SOUTHERN SAN JOAQUIN MUNICIPAL UTILITY DISTRICT

Addendum 2

**SPECIFICATIONS NO. 26-02
CARATAN RECHARGE PIPELINE**

September 11, 2026

NOT TO SCALE

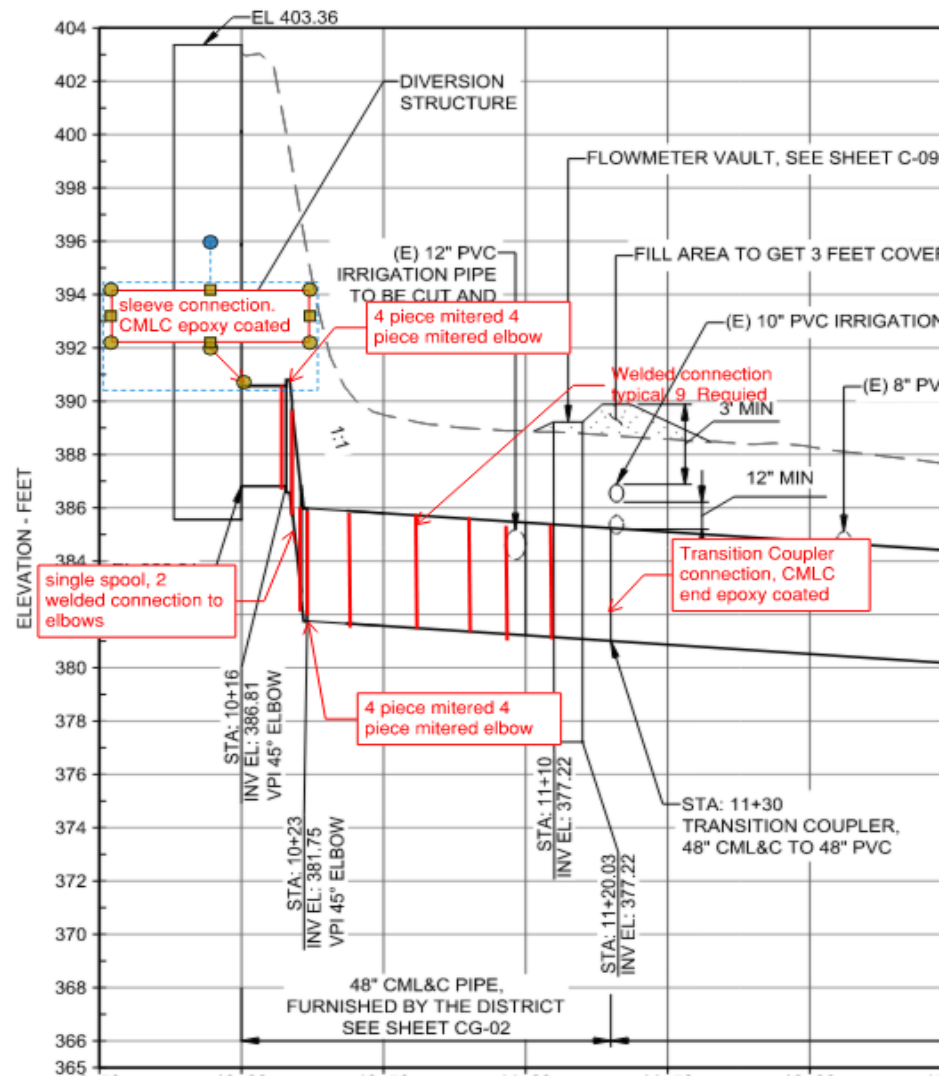
- c. *Question:* Will they have holdbacks and if so, what is the length of the holdback?

Answer: The pipe will have 6" ends uncoated where welded joints are required. The Contractor shall anticipate 9 welded joints. The Butt strap materials will be provided by the pipe supplier. Modify the butt strap detail as follows:
